4. CASE 24.103, 17 THAYER STREET, Hiram S. Read/Thomas Northrup House, 1853 (COLLEGE HILL)

Applicant/Owner: Stonehenge Partners LLC, PO Box 2332, Providence, RI 02906

Proposal: The scope of work proposed consists of Major Alterations and includes:

Project: Multi-Family Residence – Read & Northrup House
Address: 17 Thayer Street, Providence, RI 02906
Date: 10 August 2024
Re: Application Information

1 EXISTING WINDOW
A2.1 1" = 1'-0" UNIT "B"

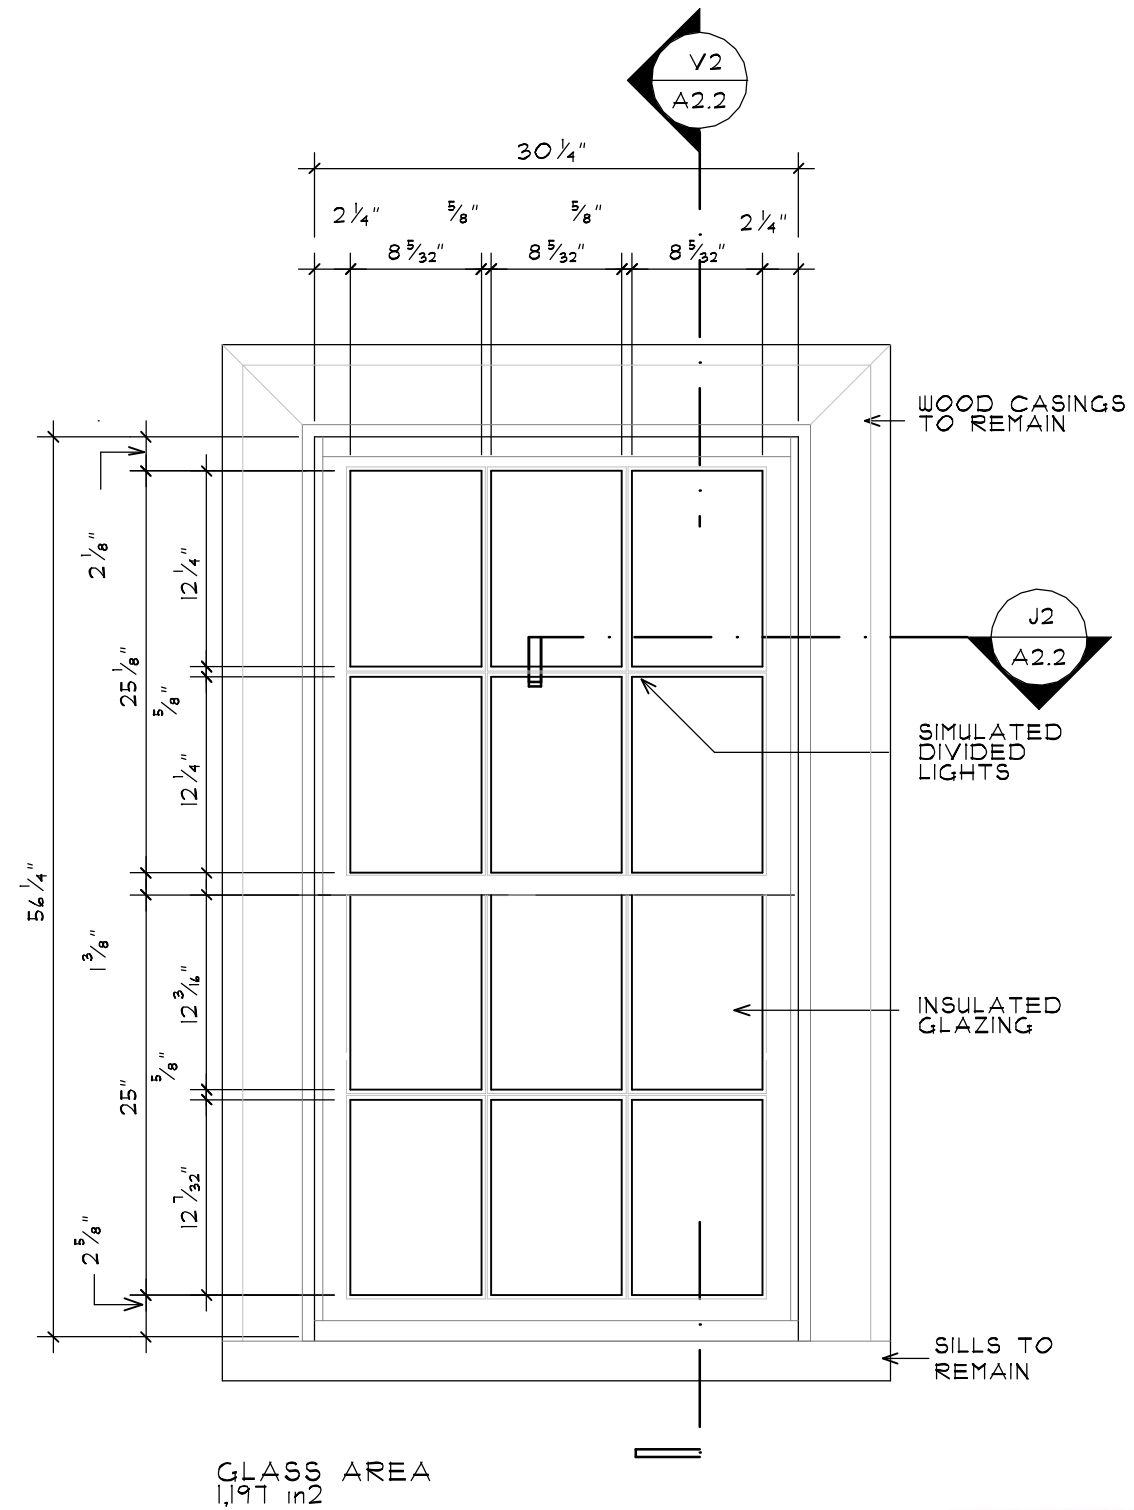
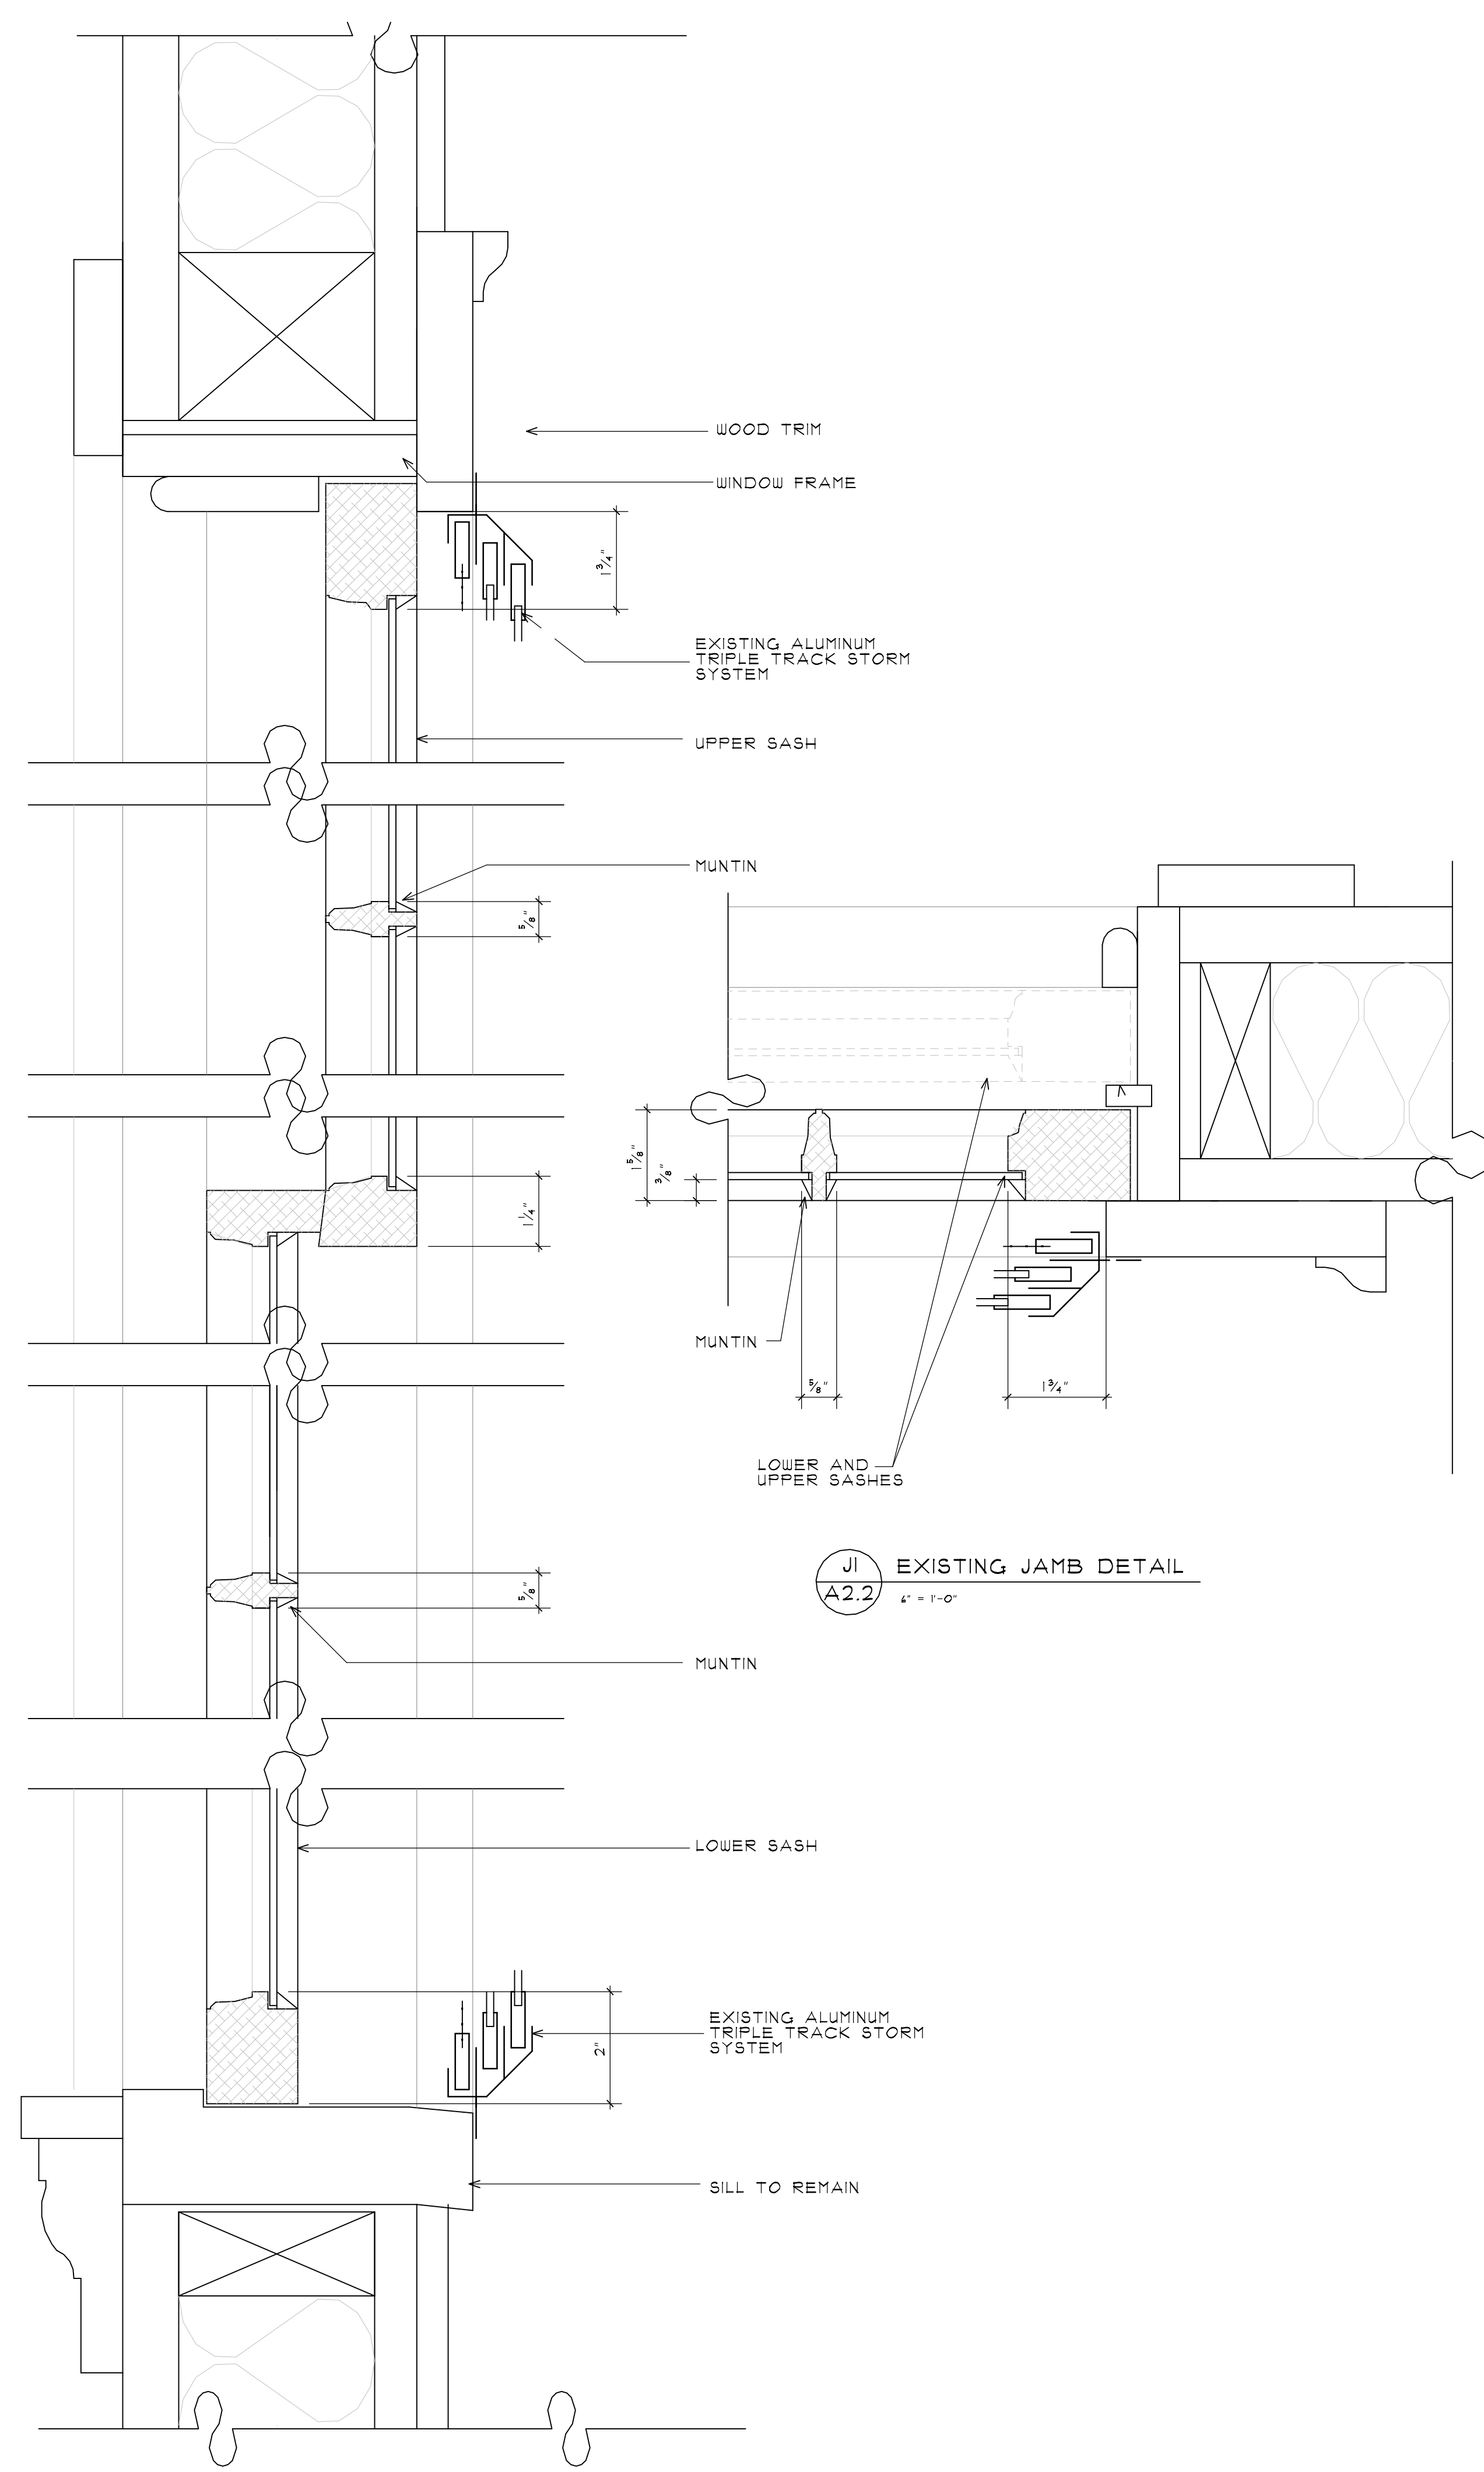
- Aesthetics – The Owner is willing to install replacement window sashes which are nearly identical to the existing. The muntin size and spacing will be matched. The difference in glass area reduction is 6.2% for unit “B”. The new sashes, along with removal of the storm windows, will result in windows which are close to the original in size, function, appearance and profile depth with windows within the wall plane, which is diminished by the storm windows.
